2014 ANNUAL MONITORING AND MAINTENANCE REPORT

Ross Island Sand & Gravel Company
Portland, Oregon

Revised December 2014

Annual Monitoring and Maintenance Report

FIGURE 3
2014 vs. 2001 Surface Comparison

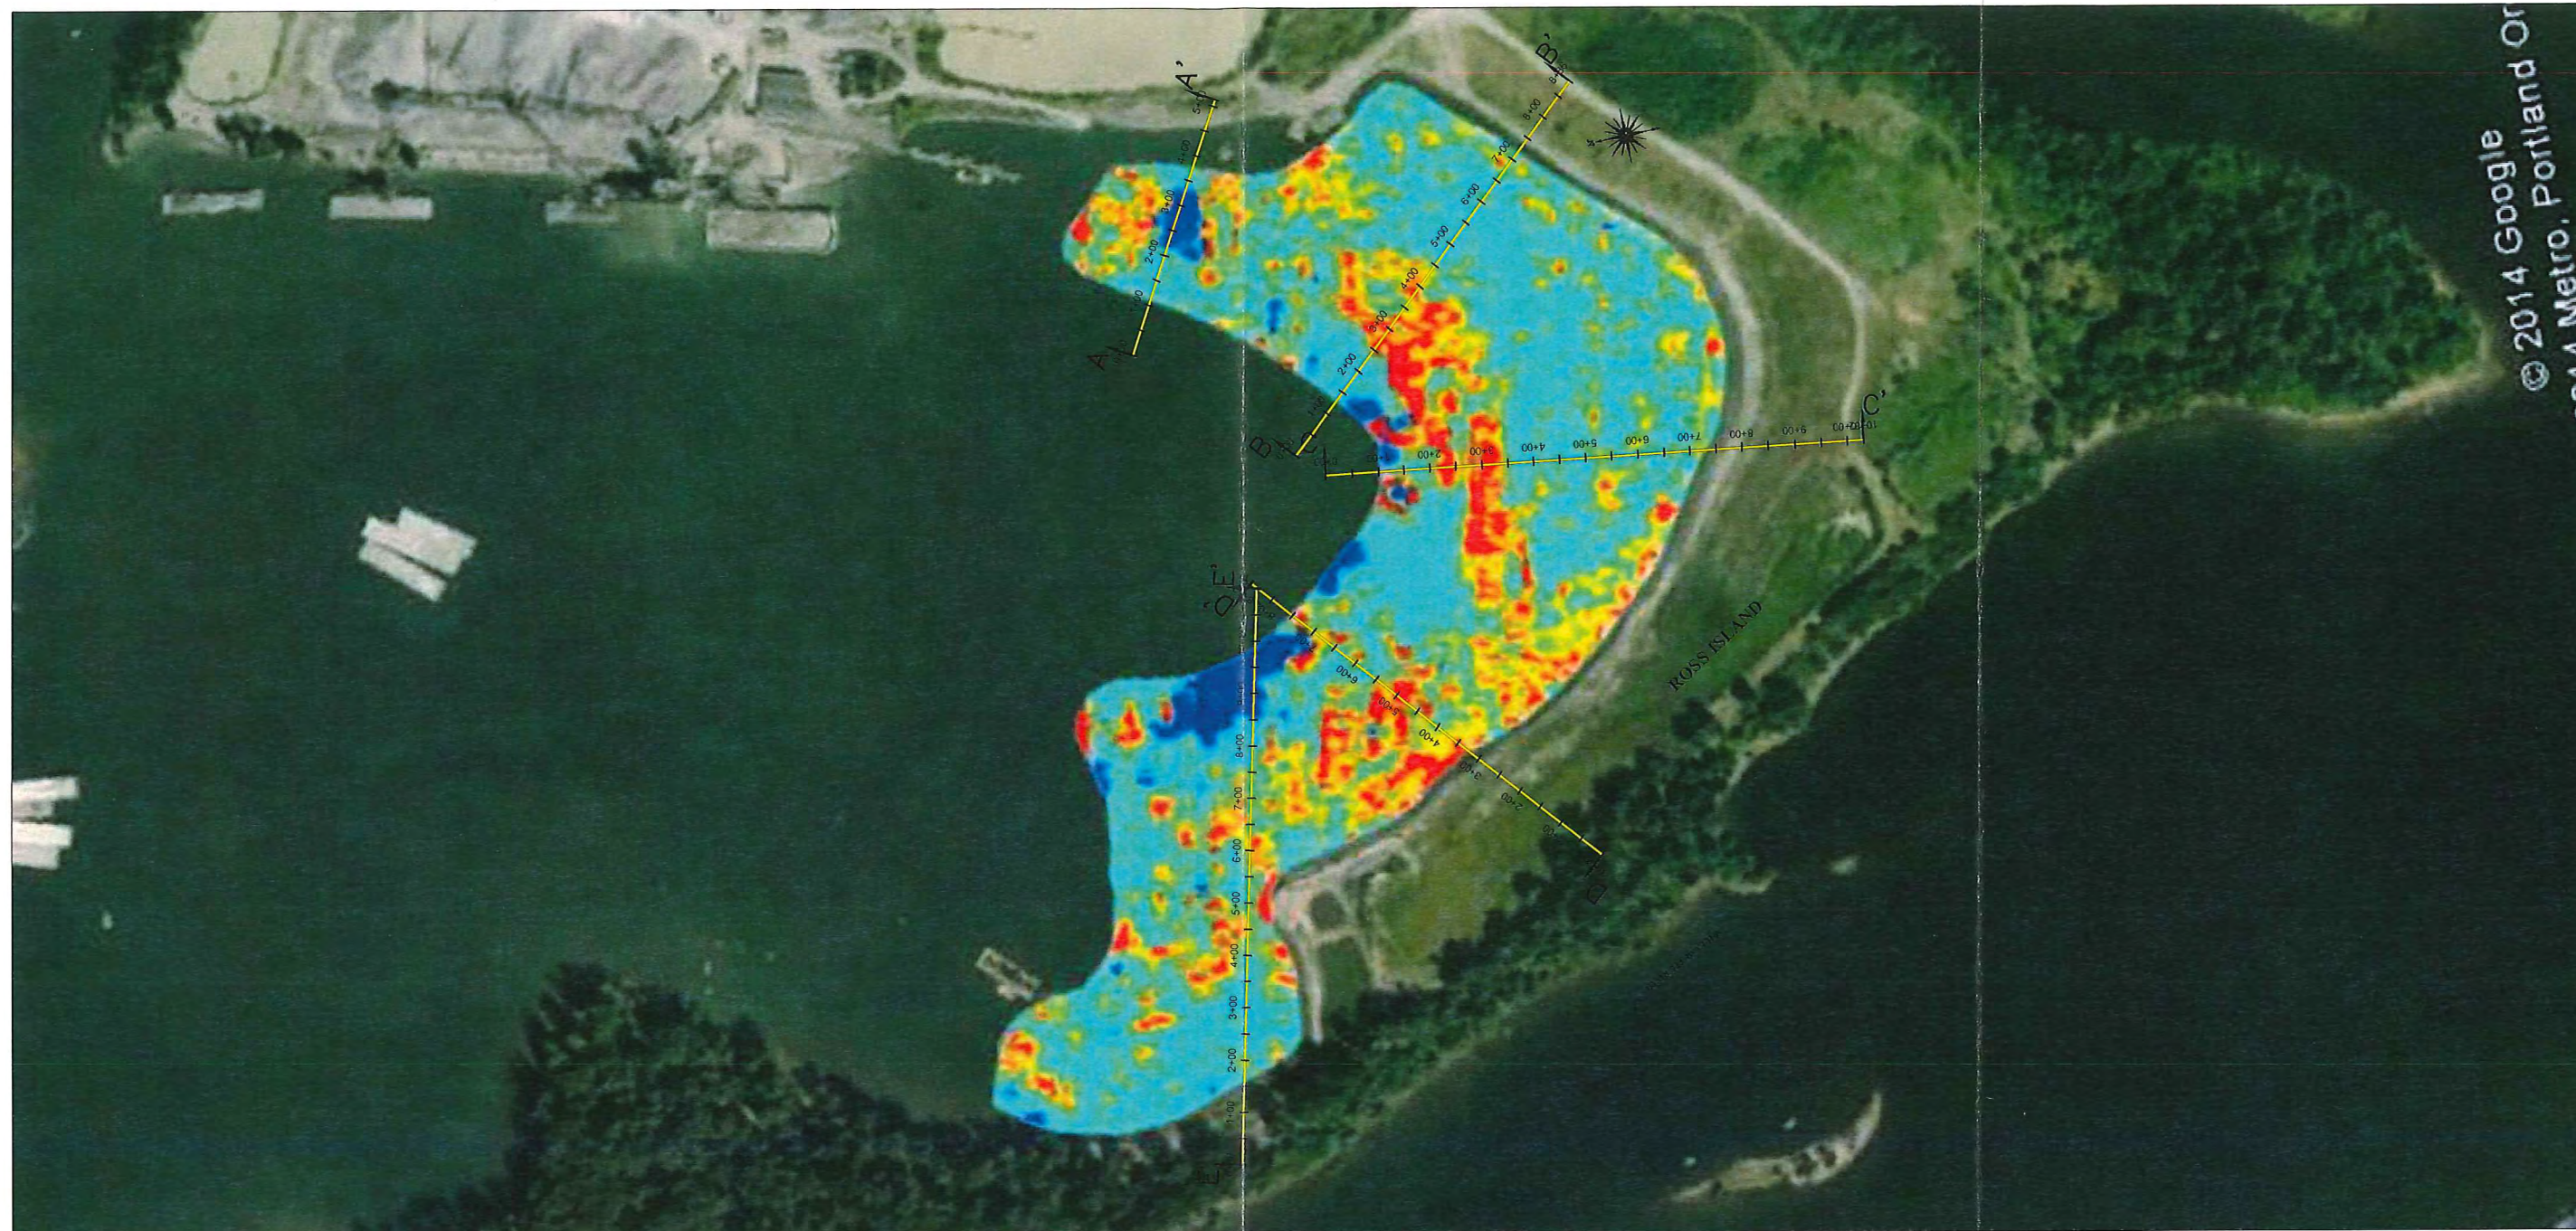
Response to review comment number 2 from DEQ letter dated November 13, 2014.

Figure 3 presents a surface comparison of the 2014 survey to the 2001 pre-remedial action survey. Figure 3 indicates that the 3 foot thick sediment cap is intact at the locations in question and does not require maintenance at this time. The sediment cap continues to meet the remedial action objectives, therefore maintenance or contingency measures are not warranted at this time

2014 Annual Monitoring & Maintenance Report Ross Island Sand & Gravel Co.	
FIGURE 12 Comparison of 2013 / 2014 Zone 1 pH Samples	
Prepared by: Ross Island Sand & Gravel Co. Portland, Oregon	12/15
Date: August 2014

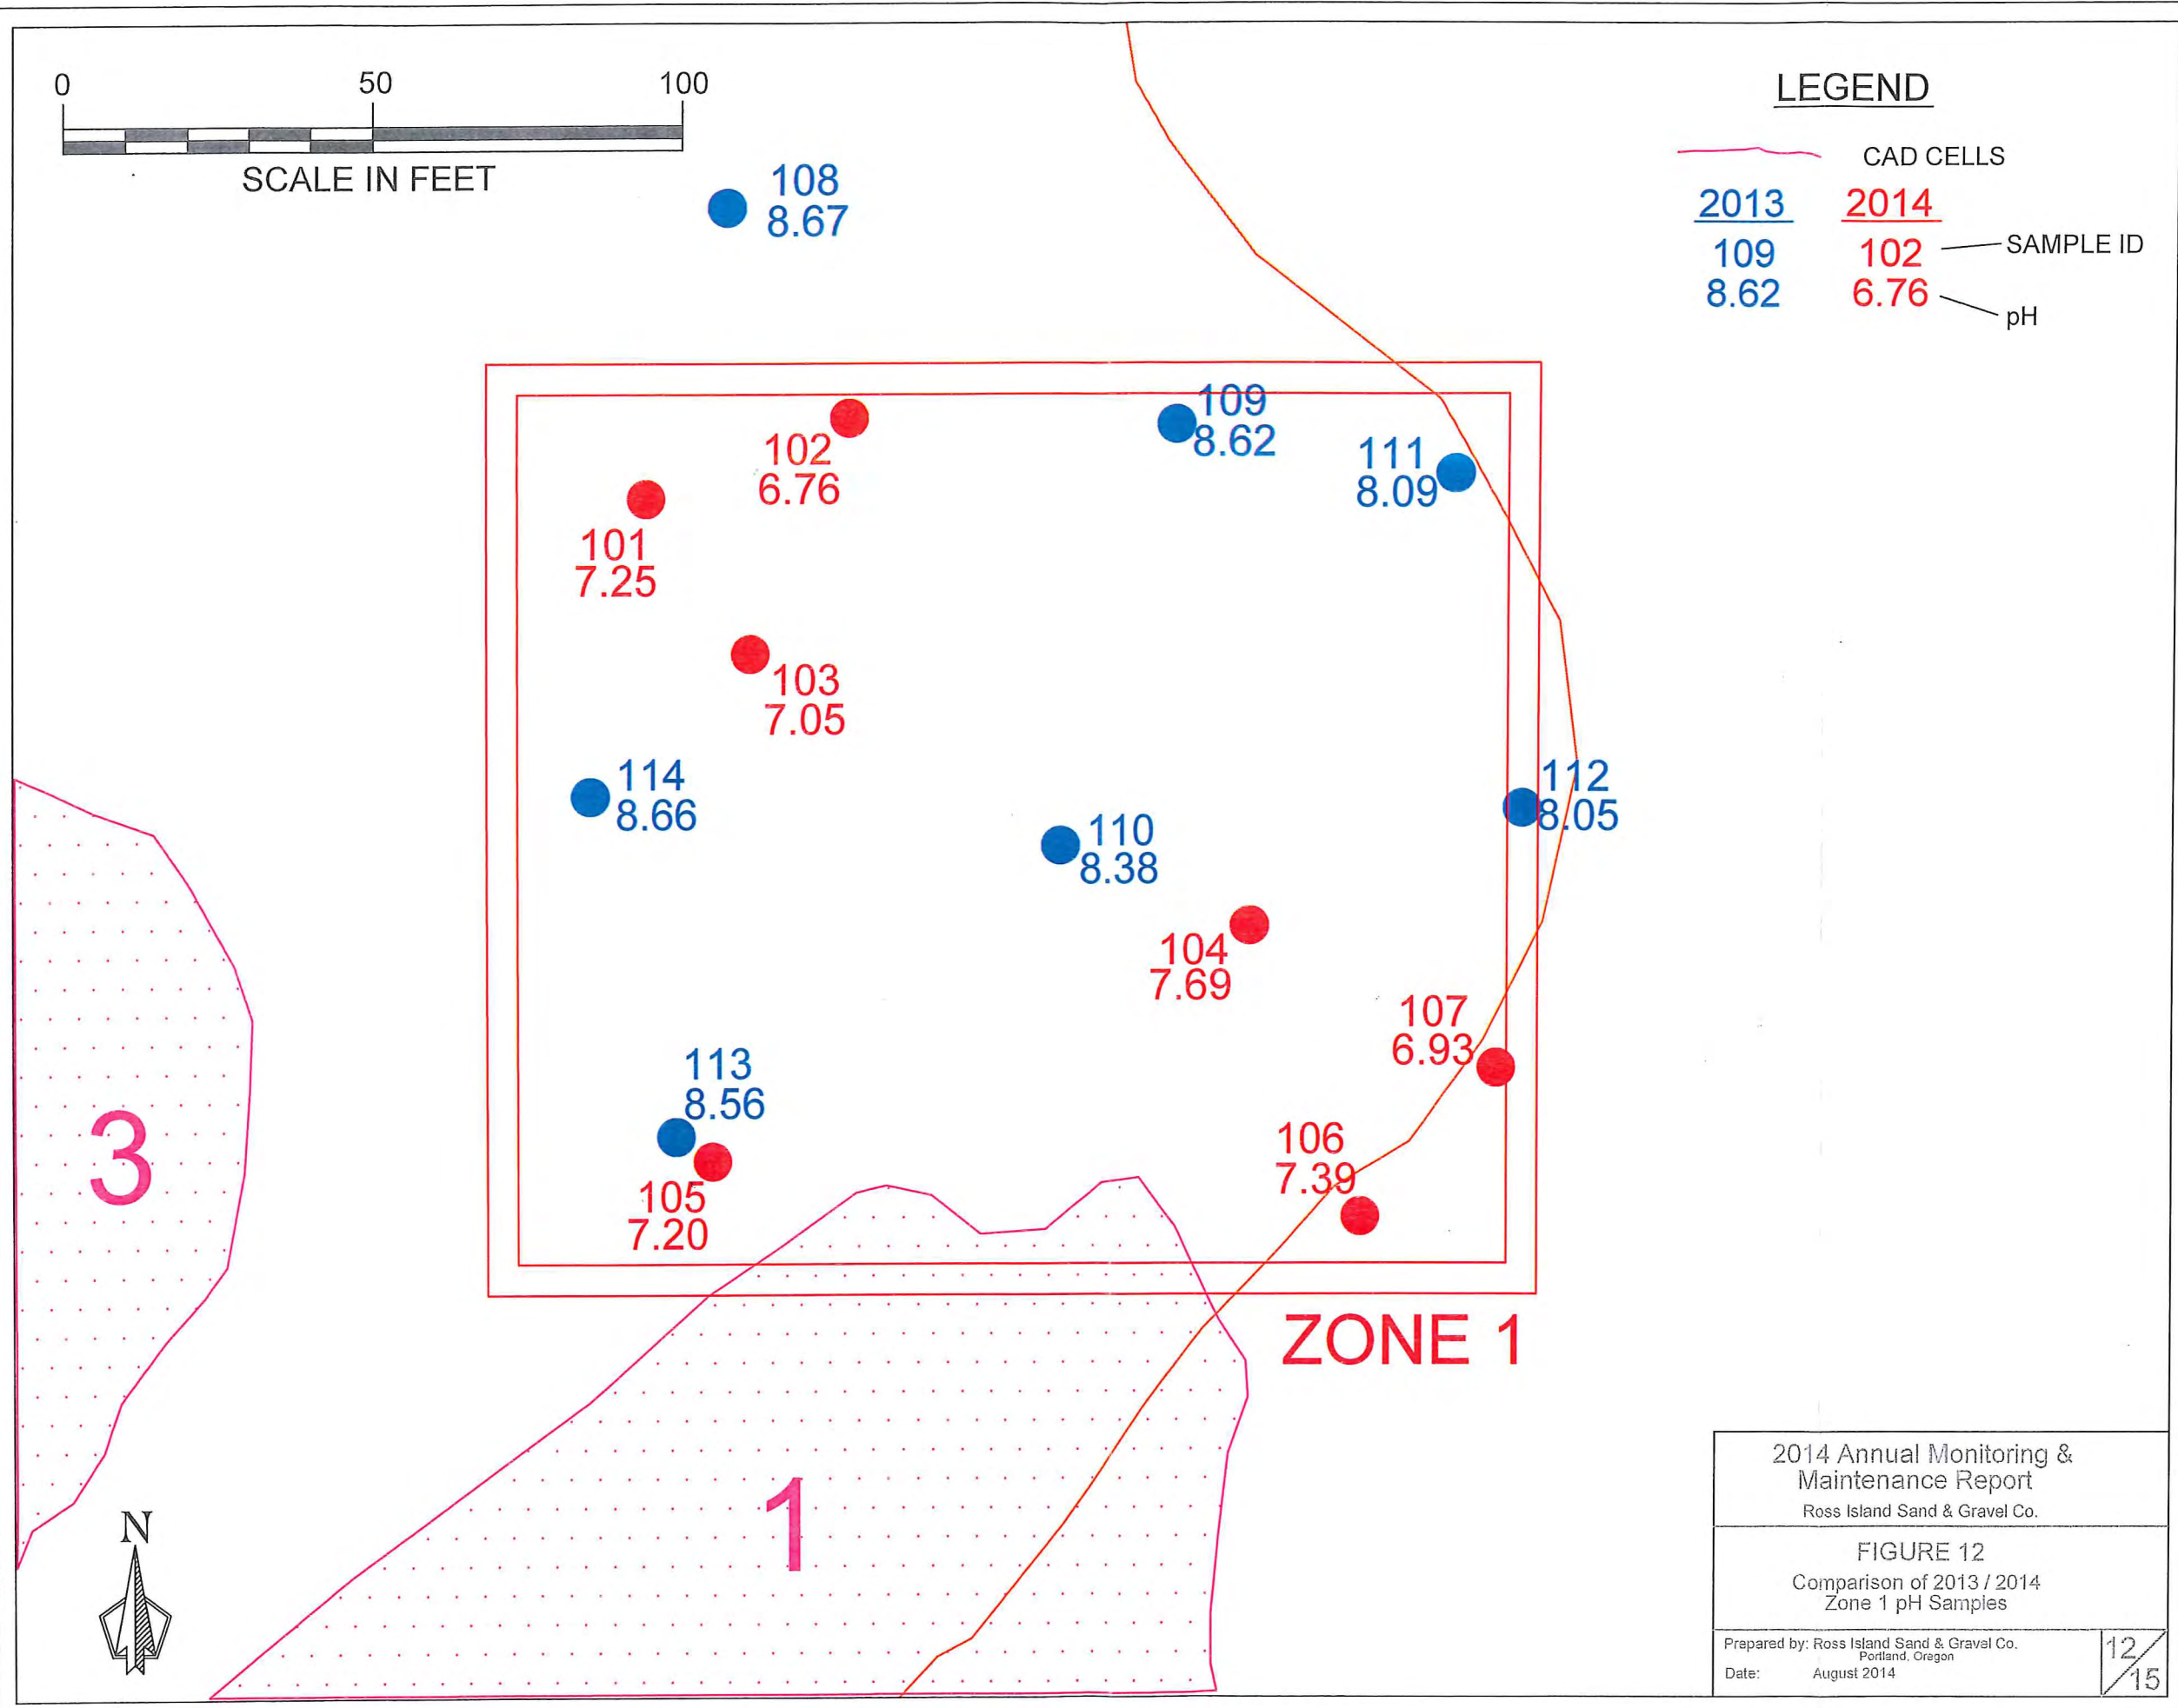
Response to review comment number 4 from DEQ letter dated November 13, 2014.

In 2013, Zone 1 was the only area with elevated pH readings above the 8.5 threshold. The slightly elevated readings were along the western edge of Zone 1 with a high reading of 8.67. This year's monitoring along the western edge of Zone 1 resulted in pH readings ranging from 6.76 to 7.25. The 2014 annual monitoring indicates that no pH readings were above the 8.5 threshold limit. As indicated in the DEQ letter dated September 26, 2014 pH monitoring need not occur next year, but will be conducted in 2019 to confirm that the sediment cap is adequately mitigating pH.

FIGURE 14
 2014 Slope Analysis

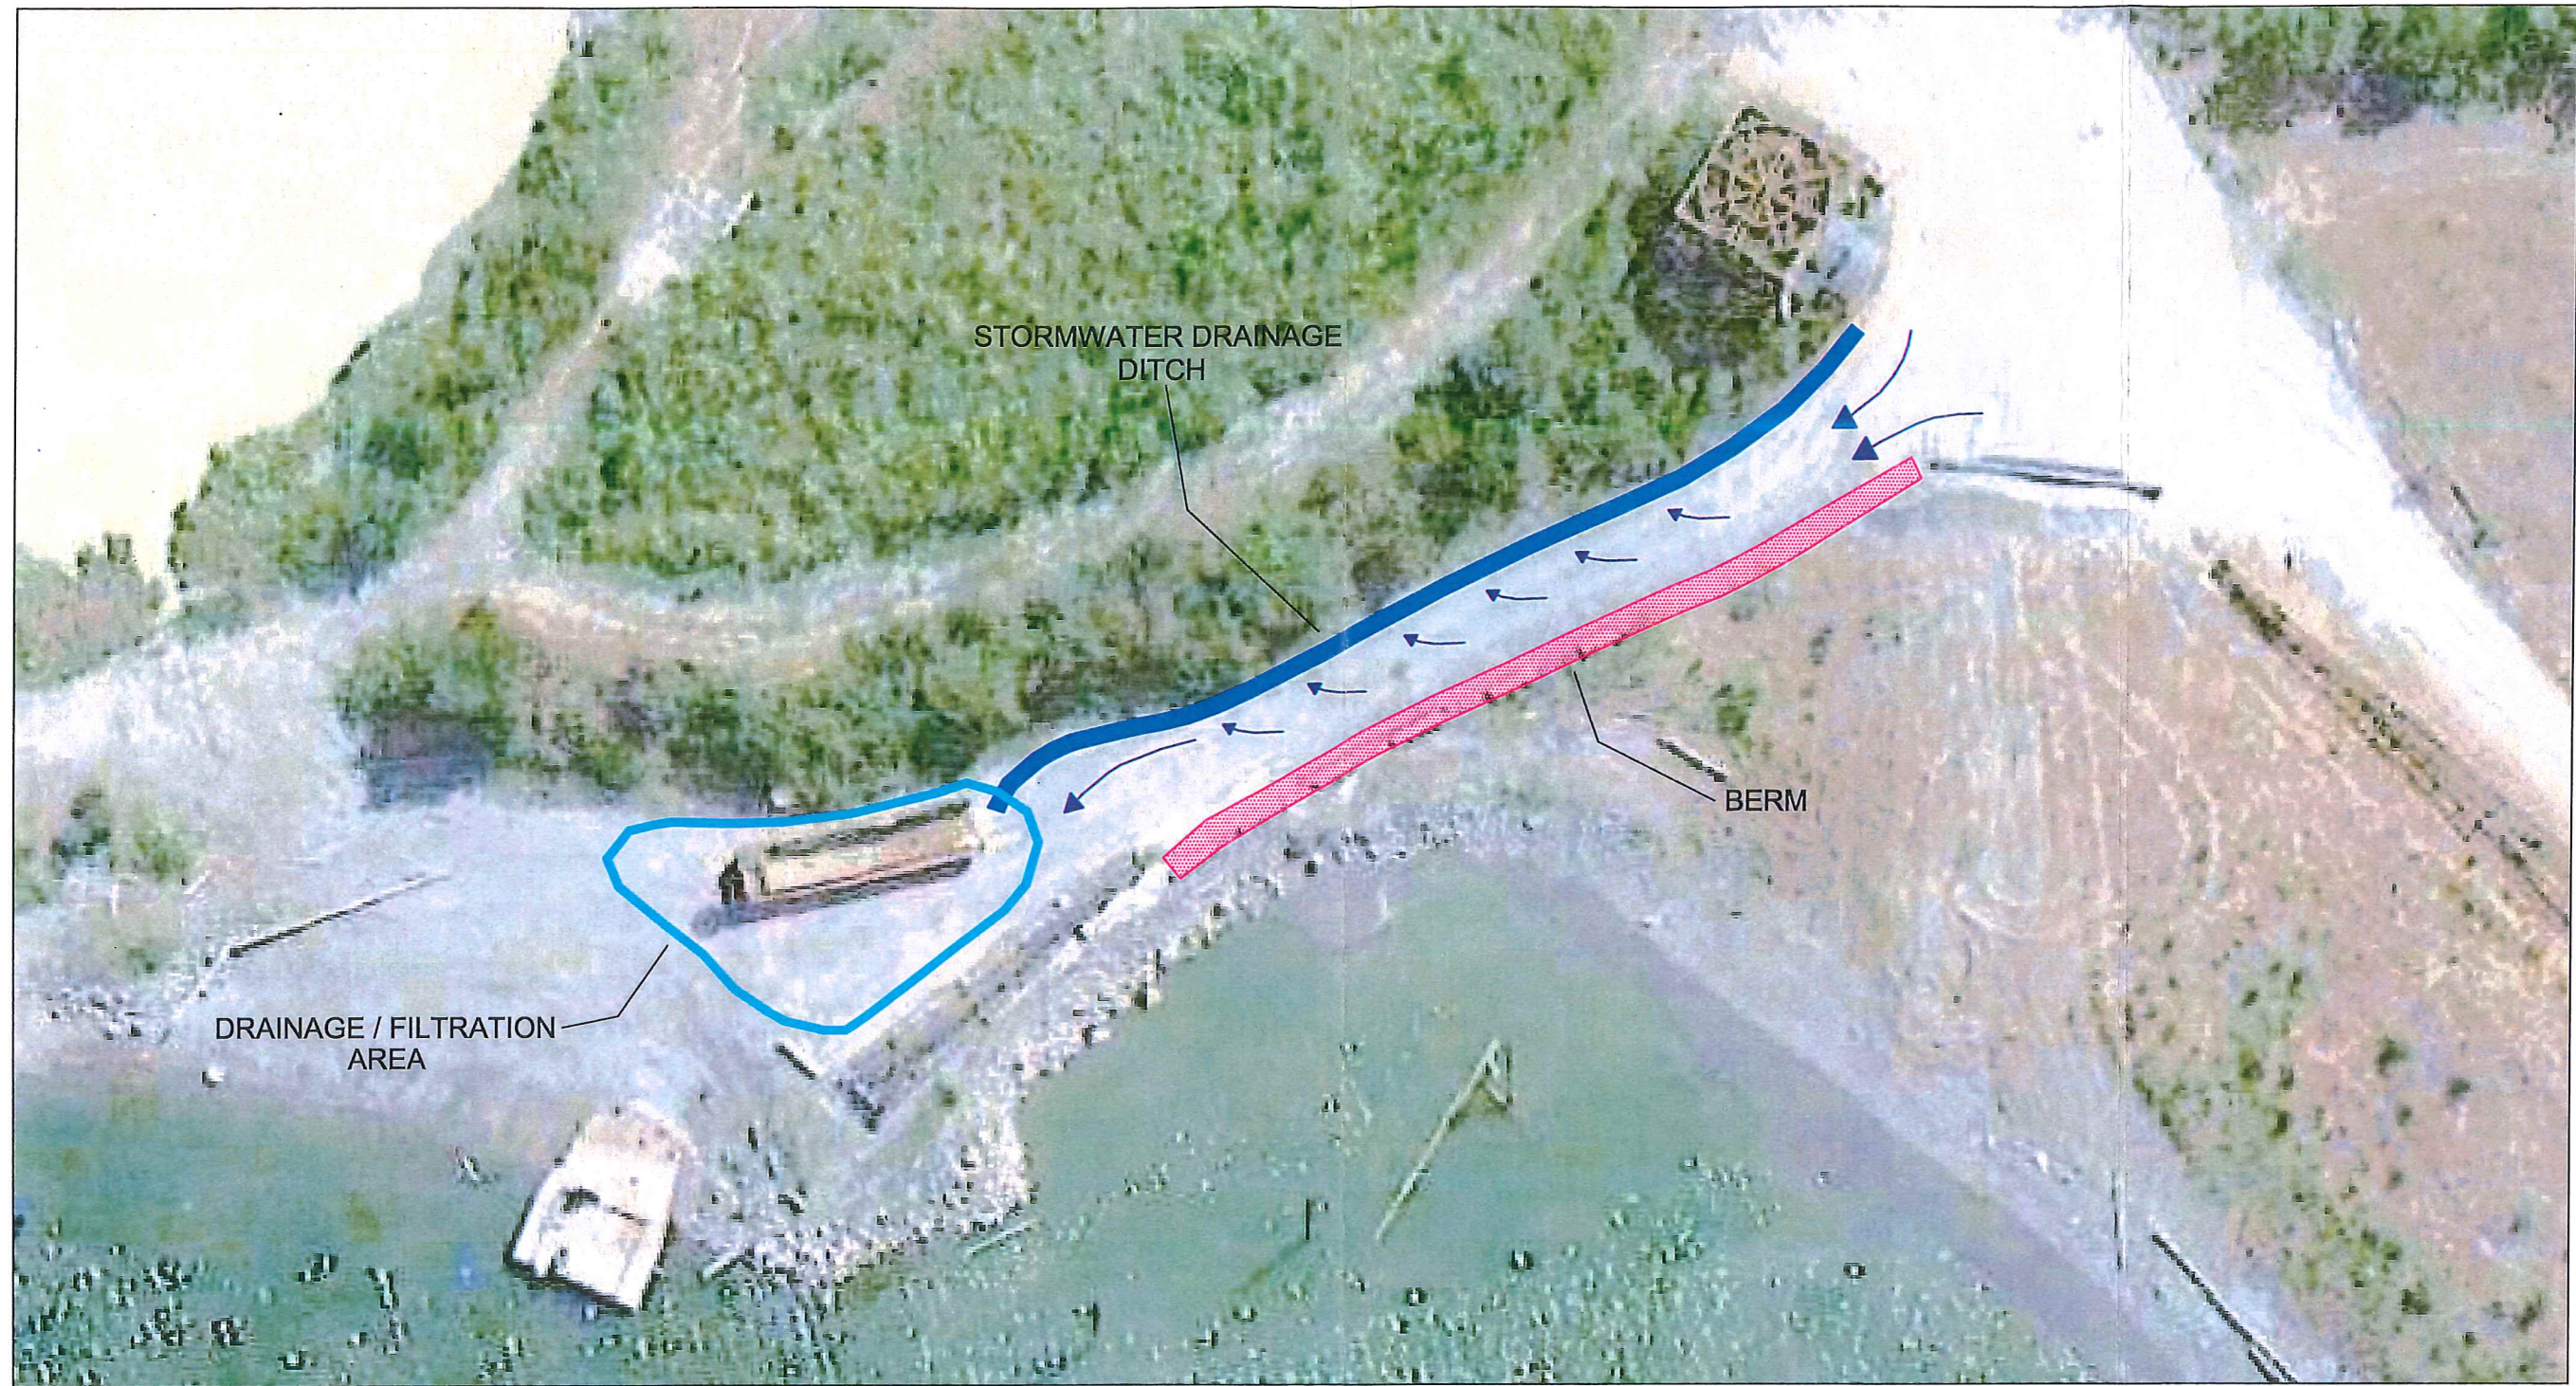
Response to review comment number 3 from DEQ letter dated November 13, 2014.

Figure 14 illustrates slopes greater than 3H:1V. Table 4 is an evaluation of changes in slopes greater than 3H:1V over the past three years. The 2014 bathymetric survey indicates that there is approximately 63,700 square feet of slope greater than 2H:1V, and 132,600 square feet of slope less than 2H:1V but greater than 3H:1V. Approximately 15,000 cubic yards of material was placed at the eastern toe of the buttressing slope for CAD Cell #5 (see Cross Section E-E' and Figure 4). This ongoing (active) fill area accounts for the largest elevation gains within the remedial action area and an increase in slopes greater than 3H:1V as compared to the 2013 slope analysis. RISG request that this temporary increase in steep slopes be permitted to accomplish the goals and objective of the 2002 Reclamation Plan.

The remedial action areas and reclamation areas overlap over a wide area in the southern portion of the lagoon. Additional fill is required to satisfy the objectives for both projects. Current fill activities have temporarily increased the areas of slopes steeper than 3H:1V. However, continued placement of clean fill at this location will provide base filling and buttressing to ensure slope

The fill material (concrete rubble) was placed in this location. Due to the nature of this material, concrete rubble is better suited to provide a stable toe or buttress that will hold unconsolidated fill material. When unconsolidated fill material is available, it will be placed upslope of the concrete rubble toe, thus reducing the overall gradient of the slopes west of this buttress that are greater than 3H:1V. Other areas within the remedial action area with steep gradients have successfully utilized similar practices with concrete rubble and unconsolidated fill material to reduce steep slopes.

When removing the 2014 active fill area from the 2014 analysis there is a slight decrease in the total area of steep slopes as compared to the 2013 analysis. It is acknowledged that final slopes will be no steeper than 3H:1V and will be achieved along with ongoing reclamation activities. Additional monitoring is not needed at this time, and annual slope monitoring will continue per the LTMMCP. Events that would have required additional monitoring, such as a 6.0 earthquake or 24.0 feet datum flood, did not occur during the reporting period.
